Comment (#167):

(TDL #385 D2.2)

Comment: Do we need the spec for Irms in 145.3.8.4?

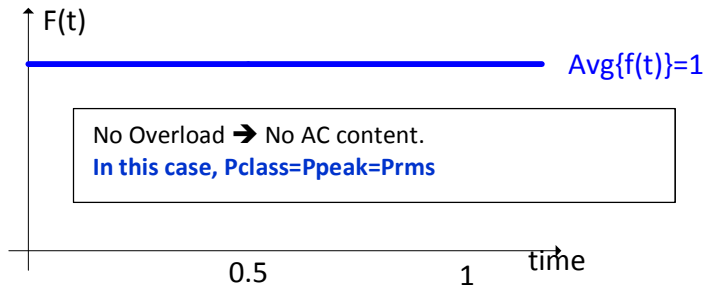
However our problem is different.

- The DC voltage is pretty much constant with negligible ripple voltage.
- The current has AC component on it which is often hard to measure its peak and duty cycle due to random nature of the load within a 1sec time window.
- So how we will ensure that the PD meets its Ppeak specifications. The average power/current is easy to measure. The peak power and duty cycle is not.
- The problem is that if we keep the average value of the current, we need to verify that its RMS value is not greater than its average value. See examples in Annex B.

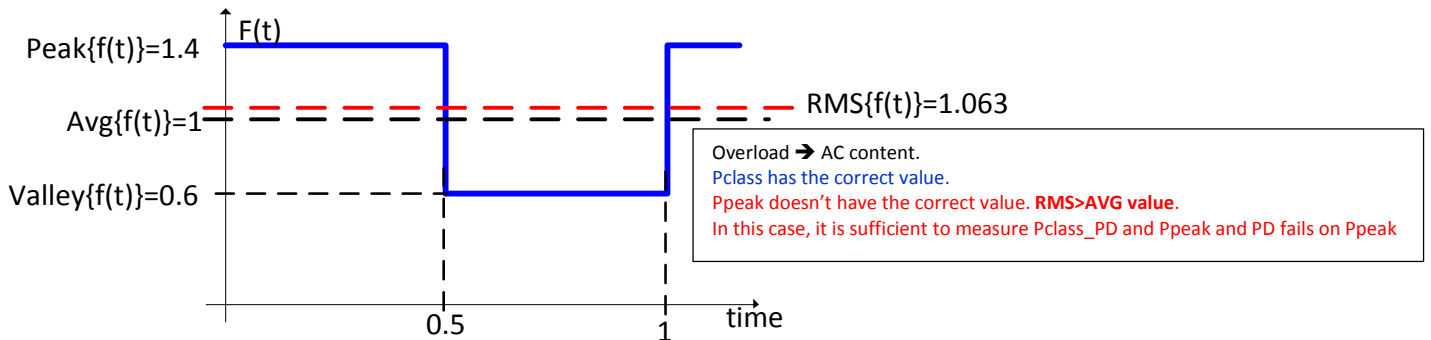
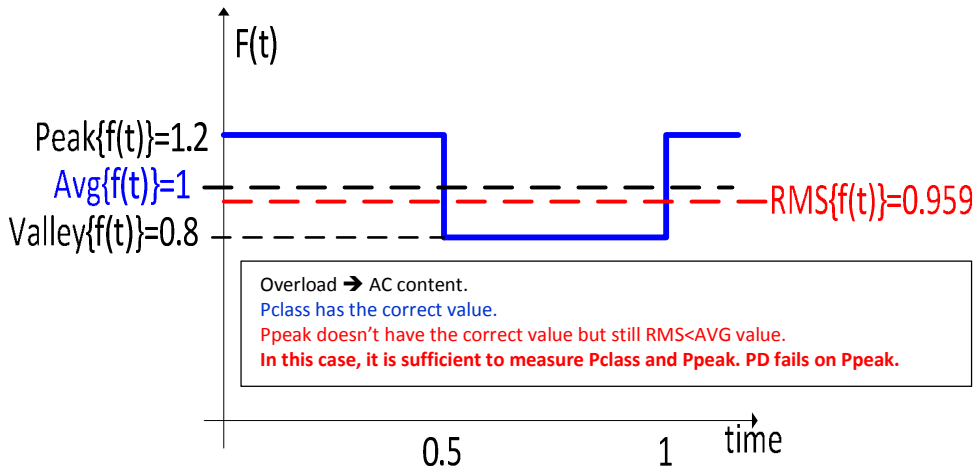
- By definition the RMS power and the average power of a given load with DC current and voltage has to be equal.

- When the Load has AC content, RMS power and the Average power are not equal.

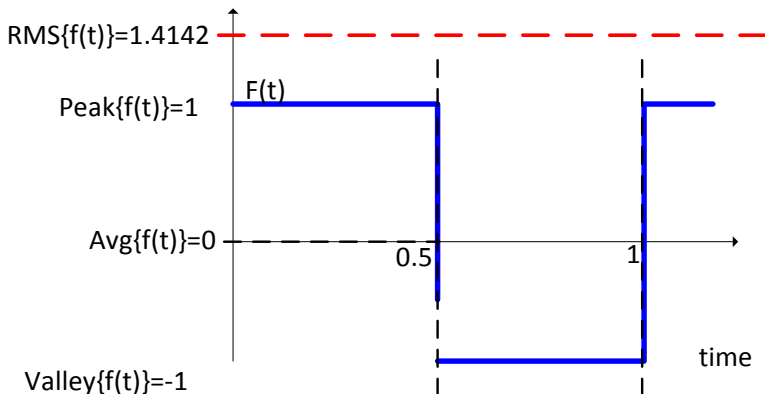
- And the famous example of all that is clearly not allowed by our spec ...
 In this example the average value is 0 and the RMS value is $\sqrt{2}$.

In order to prevent excessive heat due to RMS values > AVG values we need to set a limit to the RMS value in order to guarantee that the RMS value of the current generated by PClass will be the same as the RMS value of the current generated by PClass.

**In IEEE802.3bt we can further simplify it by asking the following:
RMS value of I_{con} and I_{con-2P} will be lower or equal
than the DC value of I_{con} and I_{con-2P} .**
